FROM:
Duke Power Company
Charlotte, North Carolina
Mr. William O. Parker, Jr.

Consists of Revision of the Babcock and Wilcox ECCS evaluation model...

Reference: Oconee Nuclear Station
Docket Nos. 50-269, -270, -287

The attached proposed revision to the B&W THETA computer code, BAW 10094, was submitted by B&W letter dated December 20, 1976 to Mr. S. A. Varga. This revision is not considered to be a significant ECCS evaluation model change since the results show a peak cladding temperature change of less than 20°F. LOCA calculations performed for Oconee class reactors at the two and six foot elevations indicates that no change occurs to the peak clad temperature. It is therefore concluded that the Oconee Nuclear Station Technical Specification remain valid to assure that the requirements of Appendix K to 10CFR50.46 are met.

FIGURE 1 HEAT TRANSFER MODES

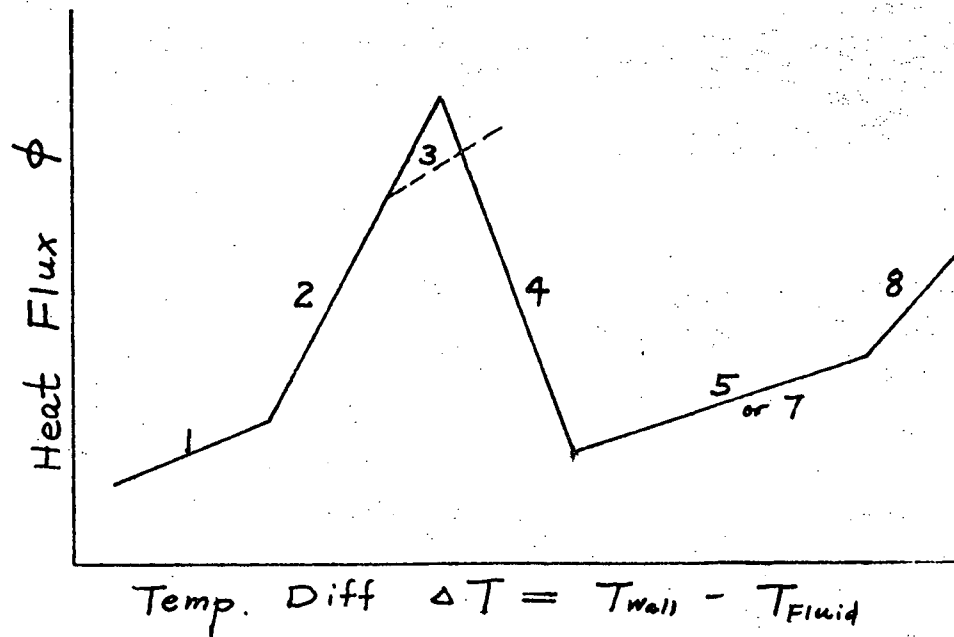
"If departure from nucleate boiling (DNB) has been calculated to have occurred for a particular axial node, both transition flow boiling and nucleate boiling will be calculated; the lower heat flux is used." Examination of the THETA6F switching logic showed that the comparison of transition boiling heat flux to nucleate boiling heat flux was not made. Rather, referring to Figure 1, a trial value of the heat flux was calculated for a particular axial node according to the fluid void fraction:

- for $0 \leq \alpha \leq .80$ nucleate boiling (mode 2)
- $.80 < \alpha < .90$ interpolation between nucleate boiling (mode 2) and forced convection vaporization (mode 3)
- $.90 \leq \alpha < 1.0$ forced convection vaporization

If the trial heat flux was less than CHF, the trial value was taken as the local heat flux. If the trial value exceeded CHF, transition boiling (mode 4) heat flux was used. To correct this, the post-DNB switching logic was modified so that, subsequent to CHF at a particular node, regression on the transition boiling curve is restricted by the critical heat flux.

In the event that the transition boiling (mode 4) heat flux is calculated to be greater than the critical heat flux, two modes were considered:

1. forced convection vaporization (mode 3)
2. film boiling (mode 5,7).

As a result of the case studies described in the next section, it was concluded that, with the corrected switching logic, the return to nucleate boiling could be replaced by a temporary switch to film boiling.

On the basis of these case studies, it was decided that the THETA version prepared for case 5 would best meet the acceptance criteria requirements.
